Service Bulletin

Bulletin No. 2017-17

Power Tilt Wire Harness—15/20 HP FourStroke

Corrected shunt wire secured with cable tie

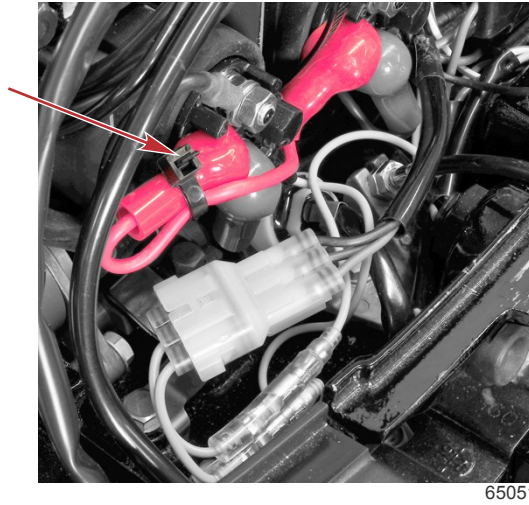
Outboards that have been reworked at the factory, or by a dealer, will have the 12-volt power supply red shunt wire secured with a cable tie. Refer to the following illustration.

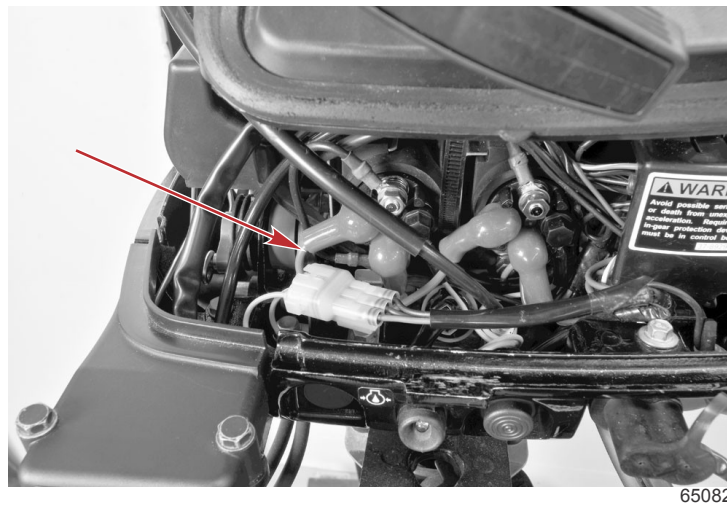
1. Locate the red shunt wire that is connected between the up and down solenoid.

Example of melted insulation

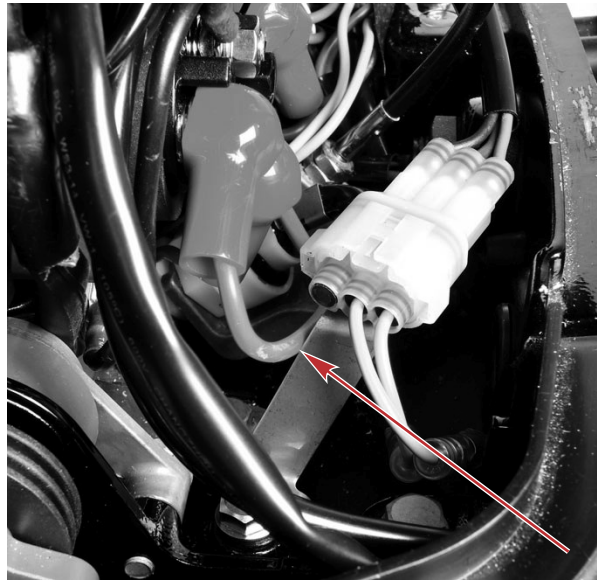
2. Inspect if the red shunt wire has made contact with the metal bracket.

3. If the insulation has been abraded through and the wire core has made contact with the metal bracket, the insulation will be melted. If you encounter a red shunt wire with melted insulation, you must inspect all wire harnesses for damage. If there is damage beyond the red shunt wire, contact Mercury Marine Technical Service or your regional service center.

Shunt wire secured with cable tie

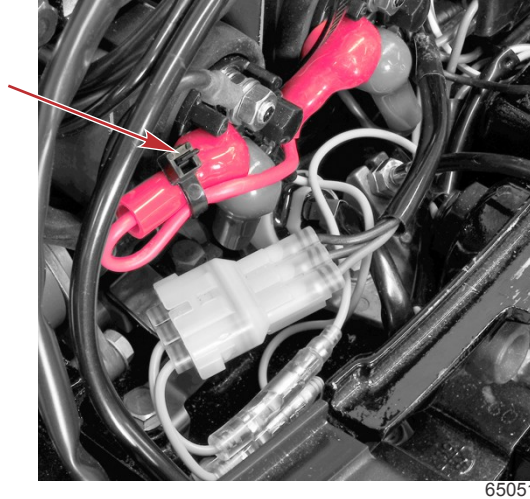
4. Remove and replace the red shunt wire regardless of its visual condition.
 - a. Remove the insulator boots from the red shunt wire.
 - b. Push the new wire through the power wire insulator boot on both ends of the wire.
 - c. Secure the wires to the solenoids.

- d. Route the red shunt wire over the down solenoid red insulator boot and secure the shunt wire with a cable tie. Refer to the following illustration.
